SUBJECT: Additional Responses to Questions on EPRI Report 110779
"Addendum 2 to EPRI TR-103237-R2 Thrust Uncertainty
Method"

PROJECT NUMBER: 689

**Responses to March 2002 NRC Comments on
Addendum 2 to EPRI TR-103237-R2**

Responses to NRC Comments on EPRI Supplemental Response Dated December 6, 2001 on Thrust Uncertainty Method

Figure 1. Cumulative Distribution Function Fit to Prediction Ratio Data

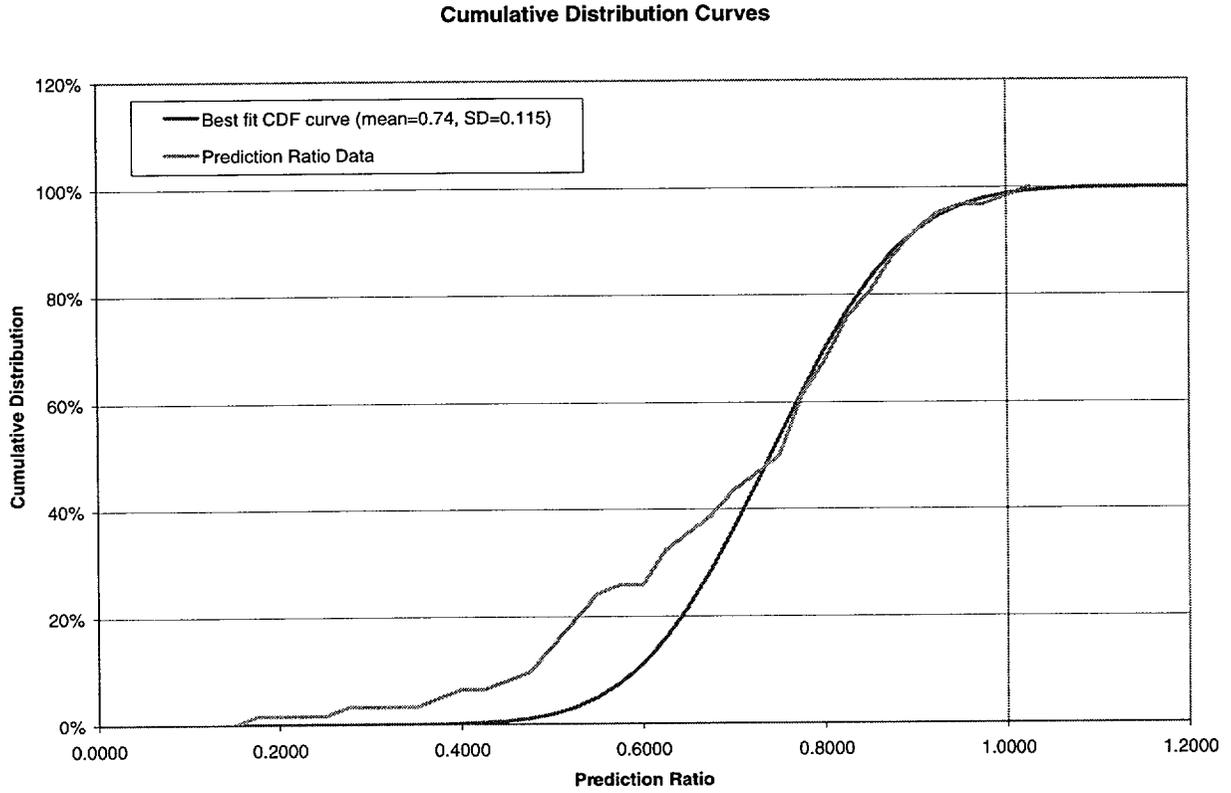
NRC Question #3. The concerns with statistical validity of 95/95 analysis need to be resolved.

ratio of 0.74 and an upper tolerance limit of 1.014. The effect of this change to the method is that the "nominal" required thrust is set to 74% of the PPM thrust prediction and the "bounding" required thrust is set to 101.4% of the PPM thrust prediction. Statistical analysis of the prediction ratio data provides additional confidence in this approach. Specifically:

- The deterministically selected average prediction ratio is 0.74, which is higher than the mean of the data (0.7) and is nearly identical to the median. A median value higher than the mean value indicates that the prediction ratio data is not perfectly normal and is skewed toward higher values. Therefore, use of an average prediction ratio close to the median, rather than at the mean, is appropriate.

- If the upper tolerance limit (UTL) of the prediction ratio data is evaluated using a one-sided tolerance limit approach for a non-normal distribution, we can say there is 95% confidence that 95% of the data is bounded by the highest data point, which is 1.014. This result suggests that even if the data were not close to normal, there is a sufficient number of prediction ratio data points (62) to justify an UTL of 1.014. The prediction ratio data used for the TUM has more of a "tail" on the left side of the prediction ratio histogram. However, a cumulative distribution function (CDF) curve with a mean value of 0.74 and a standard deviation of 0.115 fits the prediction ratio data that are higher than the median of the data set (0.74). See Figure 1. Applying a 95/95 analysis to a normal distribution with a mean of 0.74 and a standard deviation of 0.115, we can say with 95% confidence that 95% of the data is bounded by a prediction ratio of less than one.

Figure 3. Revised Figure B-3 from Previous EPRI Comment Responses

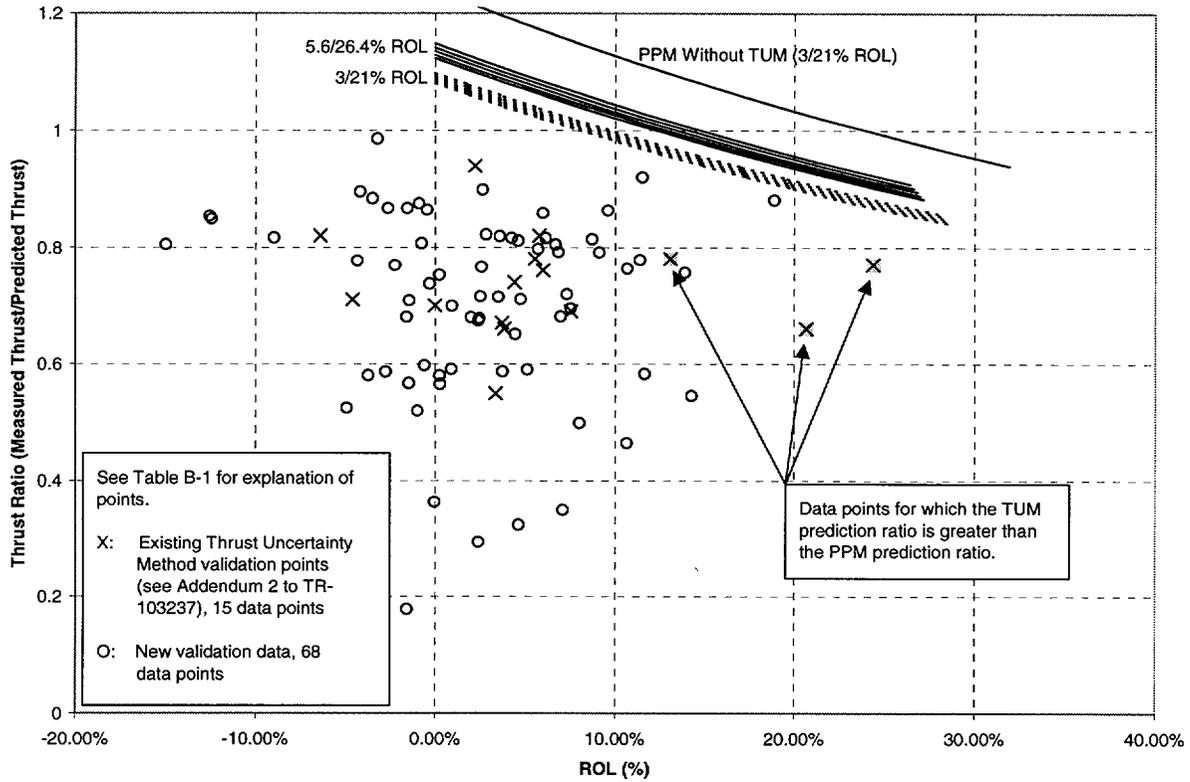
NRC Question #7. Did EPRI respond to RAI Question 8 discussion on use of rate-of-loading uncertainty for low loop test population and provide guidance for application of the rate-of-loading uncertainty based on plant-specific data?

NRC Question #9. Discuss the resolution of comments on Figure B-3 that compares thrust prediction ratios to rate-of-loading effects.

Note that data for Valves #5 and #30 are included in Figure 3, which shows the results of additional validation of the TUM. The calculated prediction ratios for the strokes of these two valves are less than the mean and median of the prediction ratio data set.

EPRI Response. In Reference (2), EPRI added lines to Figure B-3 (see Figure 3) that represent implementation of the TUM using ROL values of 3% bias/21% random, which are applicable for only the 83 data points in Figure B-3. The results indicate that the TUM would be bounding using these values for all valve strokes. The TUM report provides users with guidance on determining ROL values for use with the TUM. Users are required to use the EPRI ROL values (5.6% bias, 26.4% random uncertainty) or uncertainty values that are justified statistically using plant test data. EPRI proposes to revise the TUM report to require that any statistical evaluation of plant ROL data meet a 95/95 statistical analysis for upper tolerance limit.

EPRI Response. The resolution of comments on Figure B-3 is covered in Reference (2). Figure 3 is a new revised version that includes a line representing use of the PPM without the TUM. This new version also reflects an average prediction ratio of 0.74 and an upper tolerance limit of 1.014. EPRI would like to clarify the following two items related to the NRC's meeting report for the October 18, 2002 meeting
